Access Compliance Report

Public Rights-of-Way

(Curb Ramps)

Intersection ID: 15011	Main Street: ALBEMARLE_RD	Cross Street: COPPER_CREEK_CT	Location: NE
ADA ID: 4C826754A8BE	Ramp Type: PerpDiag	Initial Pass/Fail: Fail	Overall Compliance: No
		Severity Score: 12.5

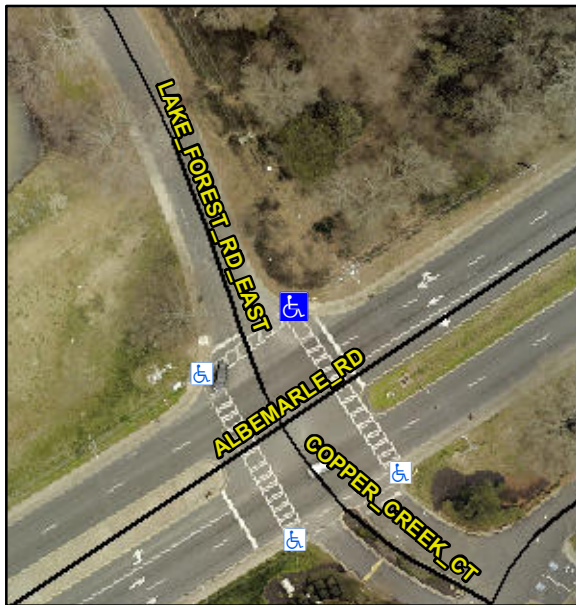
Not Found, R304.2.2

Compliance	Description	Data	Compliance	Description	Data
N/A	Ramp Length (in)	62.0	No	Ramp Slope (%)	9.5
Yes	Ramp Width (in)	48.0	Yes	Ramp XSlope (%)	0.0
N/A	Flare Type LT	N/A	N/A	Flare Type RT	N/A
N/A	Flare Slope LT (%)	N/A	N/A	Flare Slope RT (%)	N/A
N/A	Flare Traversable LT?	N/A	N/A	Flare Traversable RT?	N/A
N/A	Landing Length (in)	N/A	N/A	DWS Provided?	N/A
N/A	Landing Width (in)	N/A	N/A	DWS Contrast?	N/A
N/A	Landing Slope (%)	N/A	N/A	DWS Length (in)	N/A
N/A	Landing X Slope (%)	N/A	N/A	DWS Full Width?	N/A
N/A	Landing Curb? (Y/N)	N/A	N/A	DWS Offset (in)	N/A
N/A	Shared Landing?	N/A			
N/A	Gutter Ponding?	N/A	N/A	Gutter Slope (%)	N/A
N/A	Gutter Lip Ht (in)	N/A	N/A	Gutter X Slope (%)	N/A
N/A	Painted X Walk1?	Yes	N/A	Painted X Walk2?	Yes
	X Walk 1 Direction	To SW		X Walk 2 Direction	To SE
N/A	X Walk 1 Width (in)	80.0	N/A	X Walk 2 Width (in)	67.0
	X Walk 1 Slope (%)	0.5		X Walk 2 Slope (%)	0.3
	X Walk 1 X Slope (%)	1.2		X Walk 2 X Slope (%)	0.1

Remove & Replace Curb Ramp With Two New Directional Ramps or Equivalent. Restripe Crosswalk.
